**15 Ranulf Road
London
NW2 2BT**

**Basement Impact Assessment
Audit**

For
London Borough of Camden

Project Number: 12066-57
Revision: F1

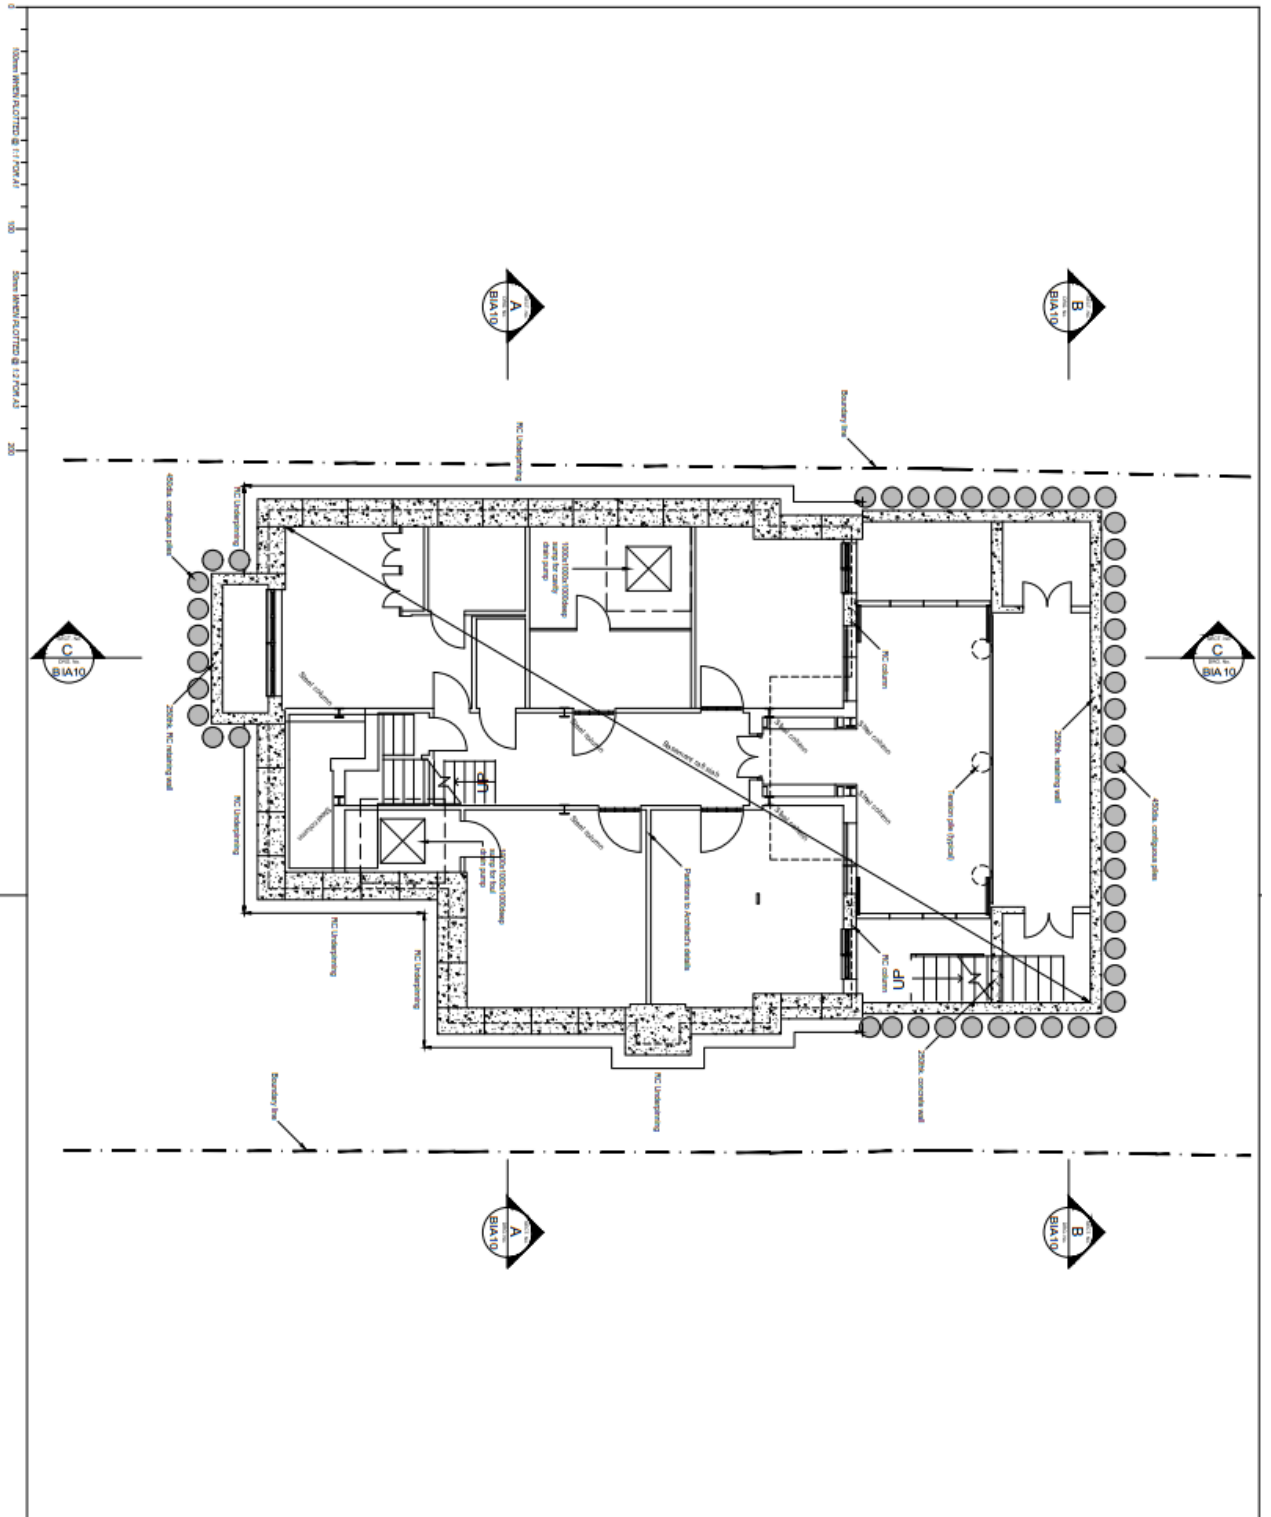
1. With regard to the slab construction proposal, section 4.04.3 suggests that the ground bearing slab will be designed to overcome possible uplift, and F3 refers to the presence of tension piles. Could you please confirm whether any tension pile is intended to be designed.
2. The construction method suggests a top down construction with both permanent and temporary propping, whilst section F3.6.1 refers to design of 'cantilever' walls! Could you clarify the type of the wall?

1. The existing ground levels slope from front to rear. There is also an existing cellar beneath the existing house. Consequently there is not much uplift beneath the house as we will only be excavating in the order of 1 metre. We have therefore concluded that the ground bearing raft beneath the house can be economically designed without the need for tension piles in this area. The weight of the house overhead will also provide adequate ballast against uplift forces. The basement raft in the rear garden however is different in that it will be excavated to depth and the lid of the basement will be daylighting above the ground. Consequently we do not have any soil weight above the structure to provide ballast. The heave forces in the rear area have been calculated and we have assessed that the most economic design for the basement raft in this area will be to have a single row of tension piles centrally. See attached BIA01The perimeter contiguous piles will also be designed for tension.
